Leckwith Quays, Cardiff

Applicant Response to Highways Comments from the Vale of Glamorgan and the City and County of Cardiff (Planning Application Reference: 2020/01218/HYB)

Technical Note Included as part of the Environmental Statement, Appendix 4.4

Extract from Drawing 70053561-WSP-XX-XX-CE-DR-103 (Development at Leckwith Quay; B4267 Highway Alignment, Relaxations and Departures; Appendix A; ')

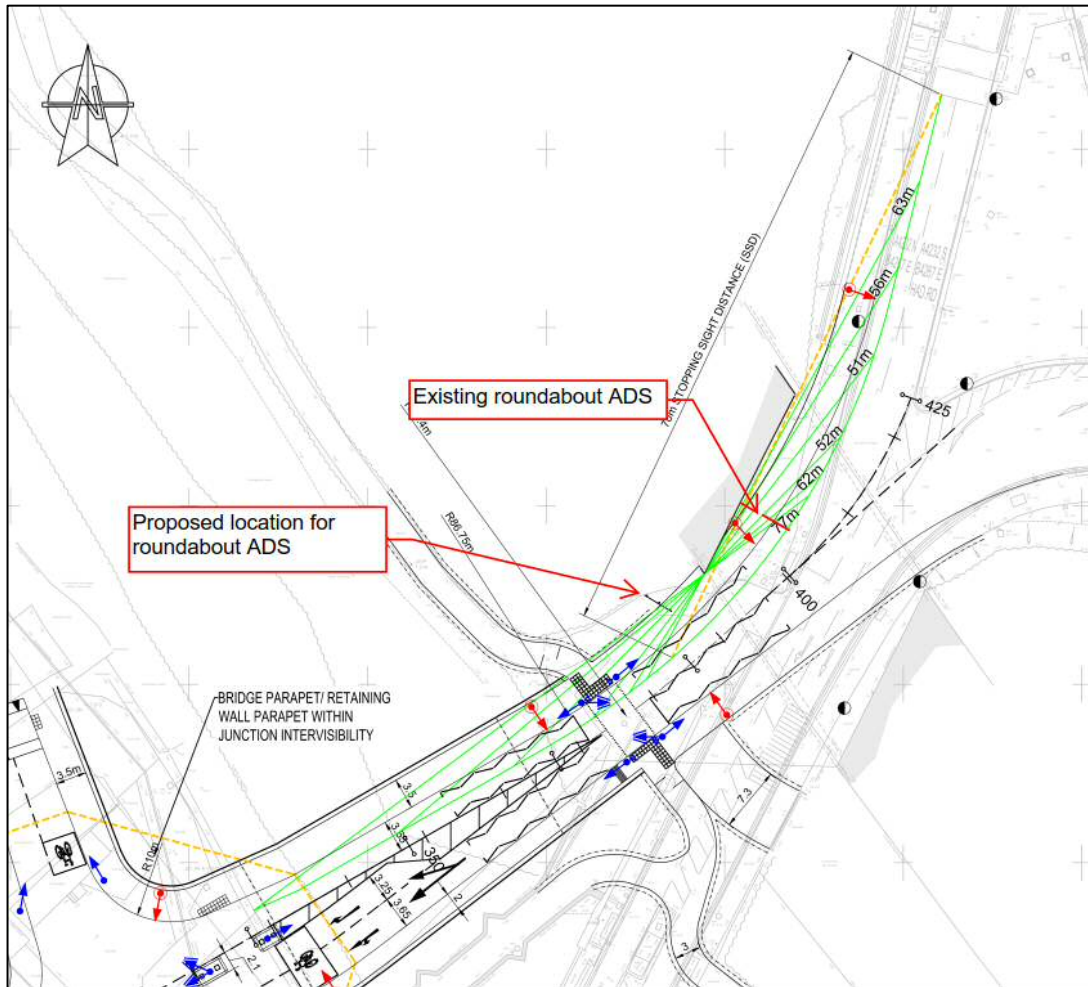
Comment from CCC

“We have concerns that the signage on the northern side of the bridge, towards the roundabout, may affect the SSD. We would expect the applicant to demonstrate the necessary signage can be positioned acceptably without affecting SSD.”

- Roundabout approach Stopping Sight Distance (SSD): The existing roundabout approach ADS is located beneath the A4232 bridge deck and will need to be relocated to accommodate the revised highway approach. SSD on the roundabout approach has been reviewed and details are contained in the submitted document ‘Development at Leckwith Quay; B4267 Highway Alignment, Relaxations and Departures’. Appendix A of that document includes Drawing 70053561-WSP-XX-XX-CE-DR-103 which shows the SSD envelope on the proposed roundabout approach. Inset A of that drawing reproduced below, indicates the existing and proposed location for the ADS. The mounting height of the proposed ADS will be increased from the existing (constrained by the bridge headroom) to ensure no obstruction to forward visibility. The exact location of the sign will be agreed as part of the detailed design of the scheme for technical approval.

Proposed Site Access Junction – Swept Path Analysis

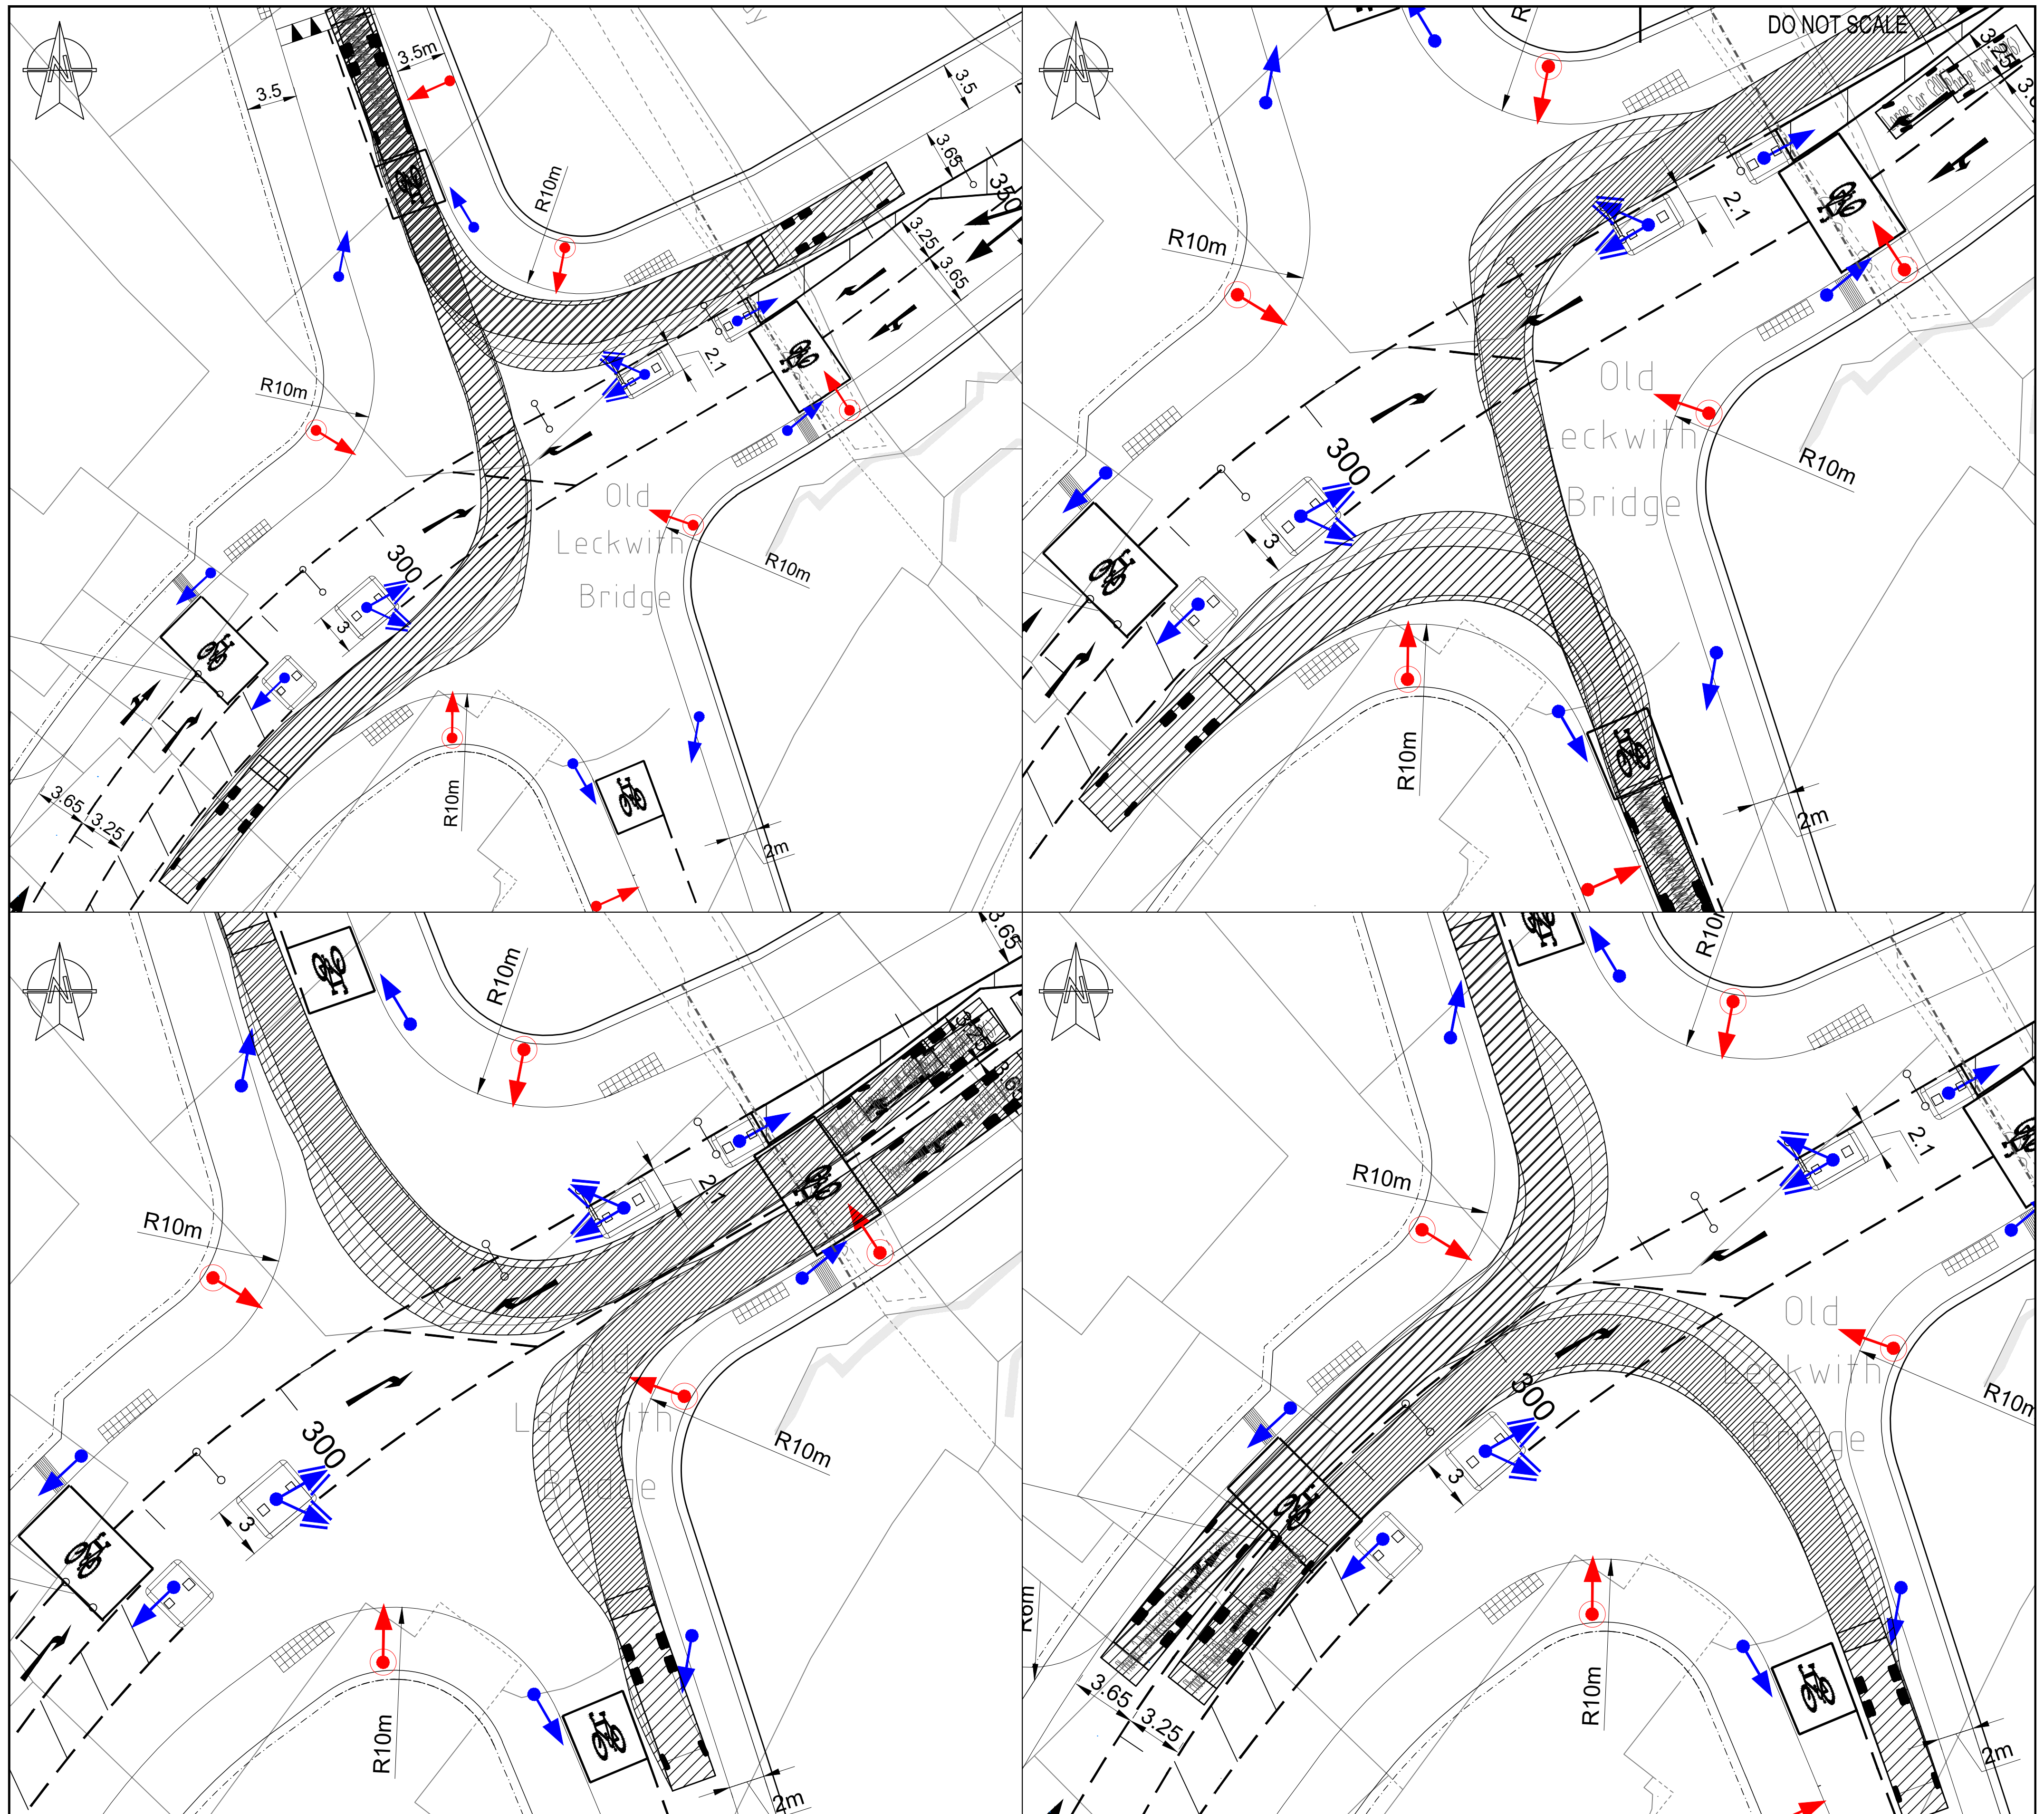
- *Signalised junction – left turns looks tight at the central island. The junction swept path tracking has been undertaken using a DB32 pantechnicon 9.570m length vehicle; the junction to be re-tracked using a 11.22m long refuse vehicle.*
- *The traffic calming (on the side arms) leading to the junction is not necessary and considered too close to the stop line.*
- *Right-turn taper looks short (turning right into the southern development), is this adequate based on a LinSig model?*
- *Do we require ASL's if there is an off carriageway facility, the removal of these this will go some way to marginally improve inter-visibility.*
- *Existing double yellow lines to be shown on future drawings.”*

- 2.3.1 The comments have been responded to in turn as follows:
- **Signalised junction:** Additional vehicle tracking has been undertaken for an 11.22m Refuse vehicle which is shown on Drawing 70053561-WSP-XX-XX-CR-DE-110 Sheet 2, included for reference at **Appendix C**. This demonstrates that the proposed layout can accommodate the left-turn movement of this larger vehicle on all arms of the junction. The tracking and kerb alignment can be further refined as part of the detailed design for technical approval.
